### BEFORE THE BOARD OF COUNTY COMMISSIONERS FOR COLUMBIA COUNTY, OREGON

In the Matter of the Request by William and Mary A Hammerbeck for a Modification from the Columbia County Road Standards for the Un-Named Roadwa to be Dedicated Through Minor Partition MP 04-25	o ) y ) ORDER NO. 52 - 2005
WHEREAS, in approximately August 2004, William and Mary Ann Hammerbeck requested a modification from the Columbia County Road Standards for an un-named roadway which was required to be dedicated to the public as a condition for approval of a minor partition, No. MP 04-25; and	
WHEREAS, a copy of the Hammerbeck's request is attached hereto, labeled Exhibit "A" and incorporated herein by this reference; and	
WHEREAS, Lonny Welter and the County Public Works Director, Dave Hill, came before this Board on December 14, 2004, with the request of the Hammerbecks for a modification to the road standards and recommended that the request be denied; and	
WHEREAS, a copy of the recommendation is attached hereto as Exhibit "B" and incorporated herein by this reference; and

subject: Road Modification for William & Mary Ann Hammerbeck

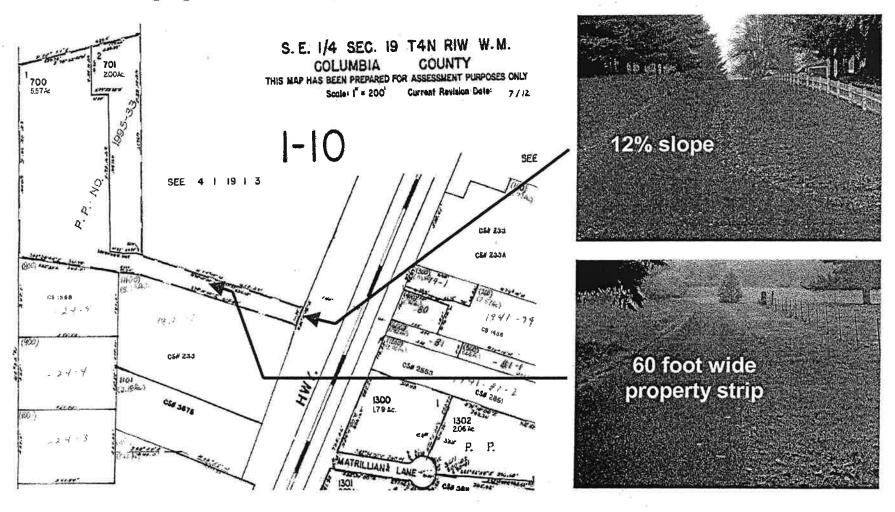
Recommend denial of the Road Modification Application for William & Mary An Hammerbeck. This situation does not meet the criteria for a modification of specifications / standards as specified in the Columbia County Road Standards, page 95. Topography, right-of-way issues, or other geographic conditions do not pose an economic hardship on the applicant. Even though the applicant's proposed construction will meet the private road requirements, as a construction alternative, said proposed construction will not meet public road standards.

The public road standards were designed and approved with public safety as a primary concern. Such a deviation from these established standards would pose a potential road safety issue, as well as liability issue. Whenever possible, the established standards should be followed, with exceptions only in extreme circumstances. Having inspected the location, there is no proof of any economic hardship being imposed upon the applicant due to terrain or right-of-way issues that would prohibit construction of a public road to County Standards.

**Deny** Application as topographic or right-of-way issues do not exist, which might prohibit construction of a public road. If the strip of property is to be dedicated for public road, the public road must be built to standards, as there is no construction obstacle prohibiting said construction.
